Landmarks Board

May 6, 2026

LANDMARKS BOARD STAFF REPORT

LOCATION: 1336 East Walnut Street

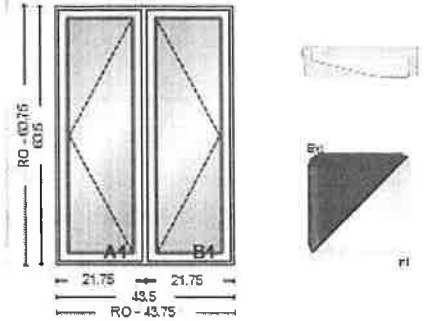
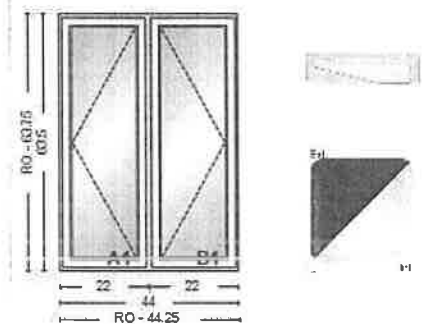
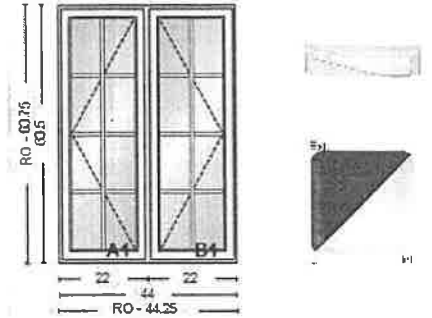
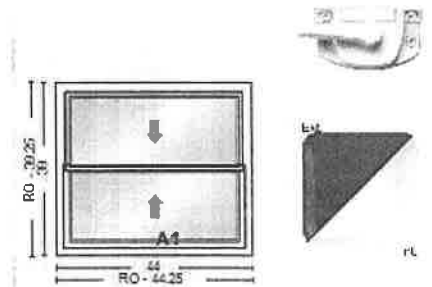
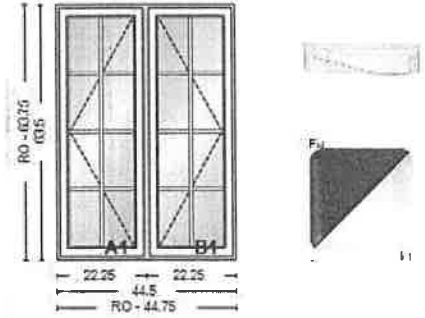
6. The proposed windows are made of fiberglass. From the information provided, it is unclear how many existing windows are vinyl inserts or older wood casement. It is unknown how many, if any, are original. An addition was added to the south side of the home in 1995. The windows on the south elevation and the two southern windows on the east elevation are associated with that addition and are not historic.

7. The *Secretary of the Interior's Standards* states, "Deteriorated historic features will be repaired rather than replaced. Where the severity of deterioration requires replacement of a distinctive feature, the new feature will match the old in design, color, texture and, where possible, materials." Photo documentation has been provided of at least one window that has severely deteriorated. The severity of deterioration of each window is not known. The replacement of windows made of wood material with windows made of fiberglass do not meet this criteria.

8. The Walnut Street Design Guidelines state that, if repairing the original window is not feasible, the applicant should consider replacing the window in kind, recognizing the importance of sash type, size, muntins, mullions, and glass. The proposed windows will match the grille pattern, size, casement style, and direction of opening, but the window material itself will be different from the original.

1. Replace wood and vinyl windows with fiberglass windows.

National Register
Photo
1336 East Walnut

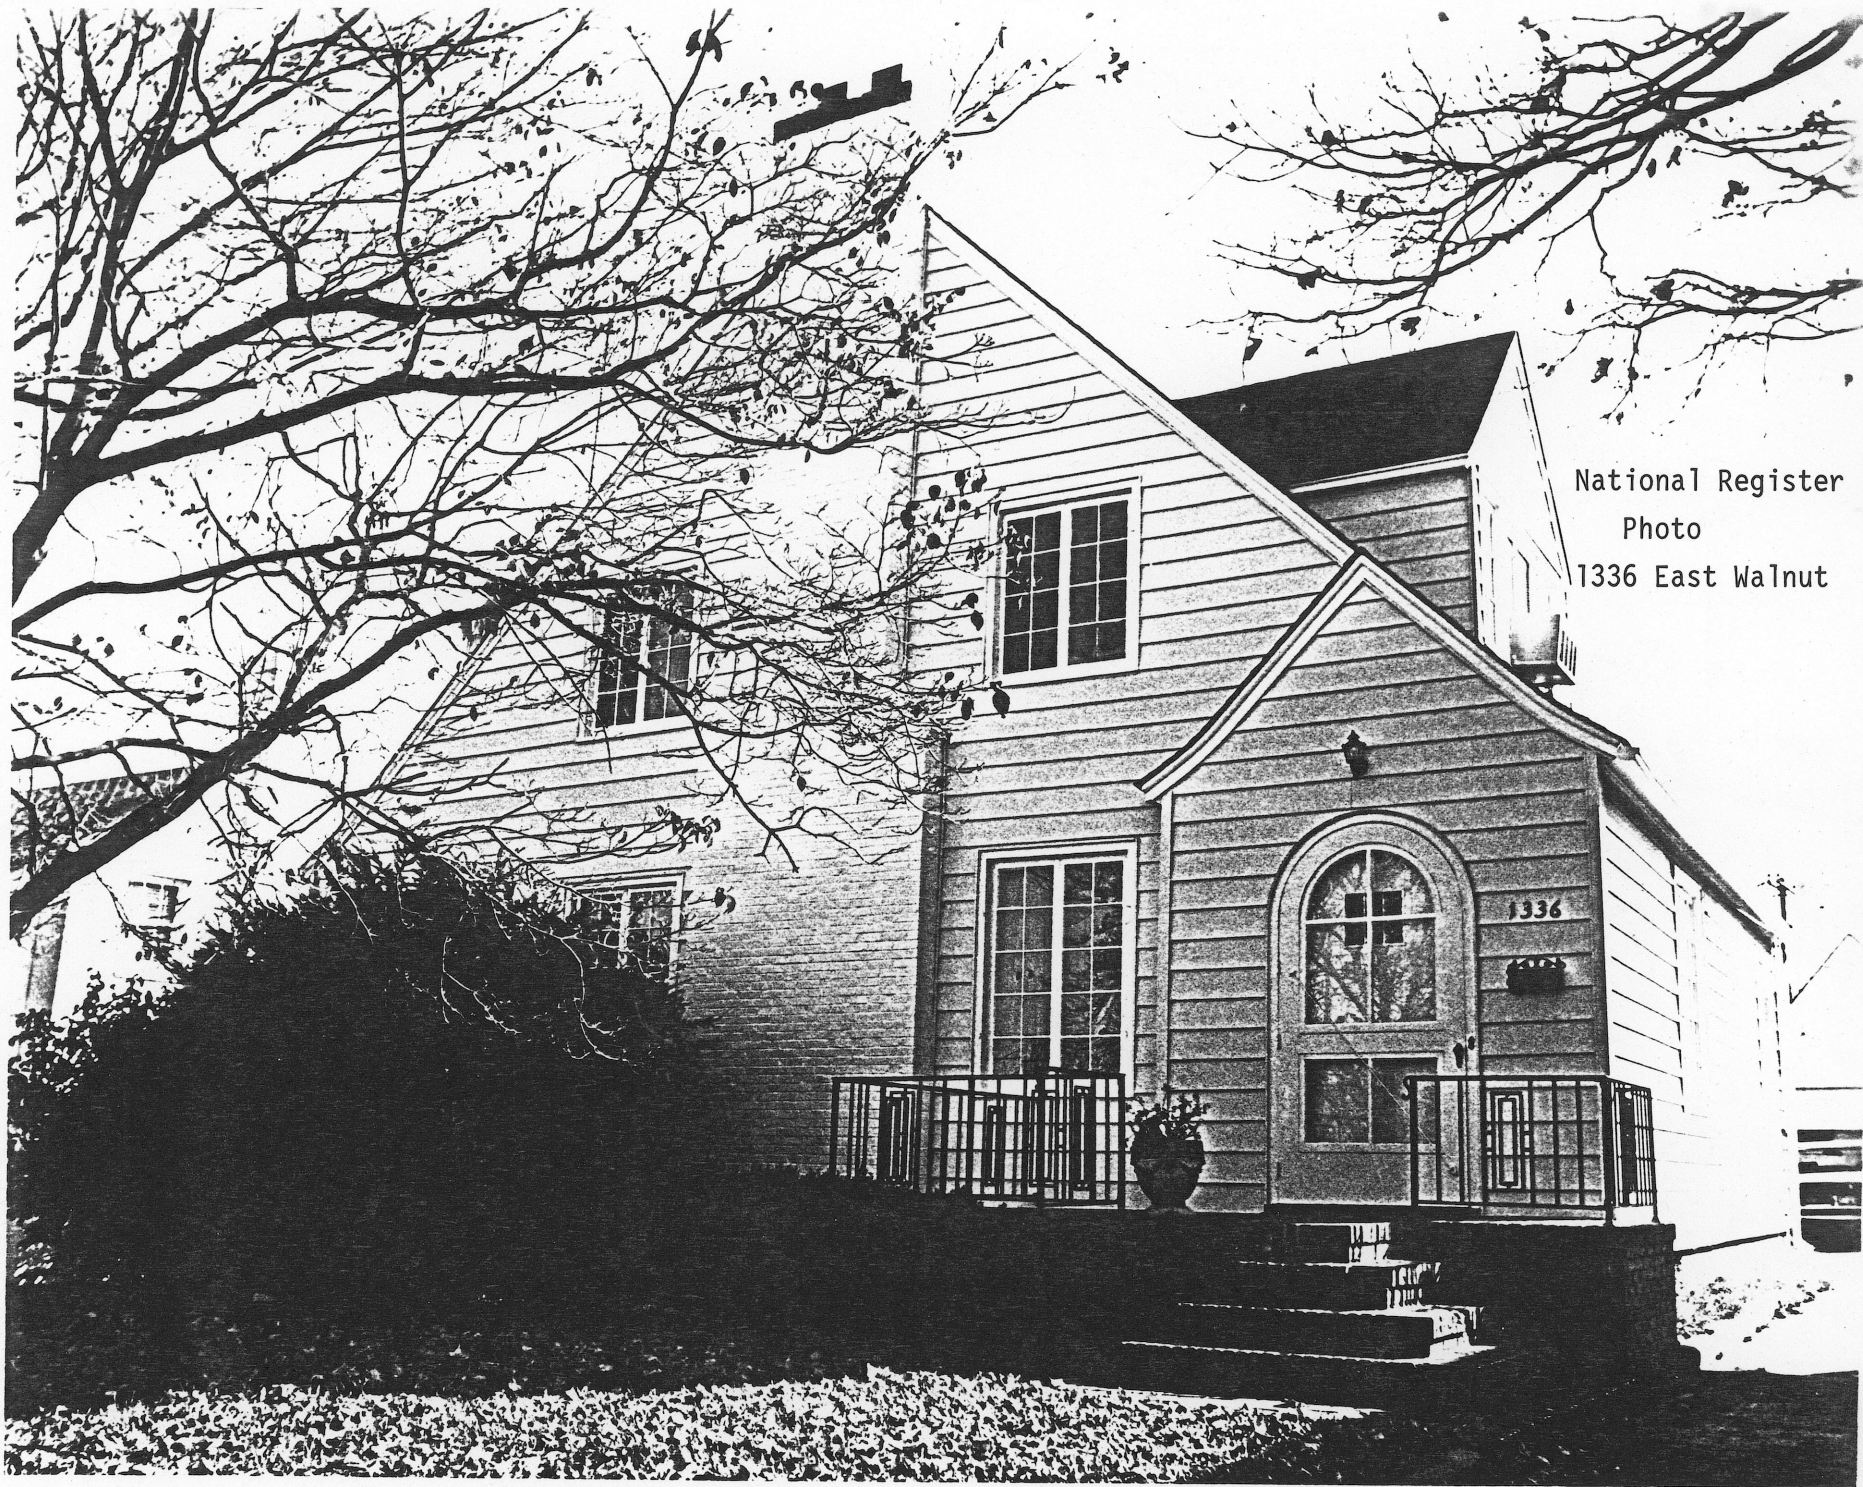
1. The house was originally clad in wood siding. Staff believes that vinyl siding has been an element of the home since the Walnut Street National Historic District nomination in March of 1985.

Staff recommends approval:

1. Replace vinyl siding with fiber cement or engineered wood siding.

Staff recommends denial:
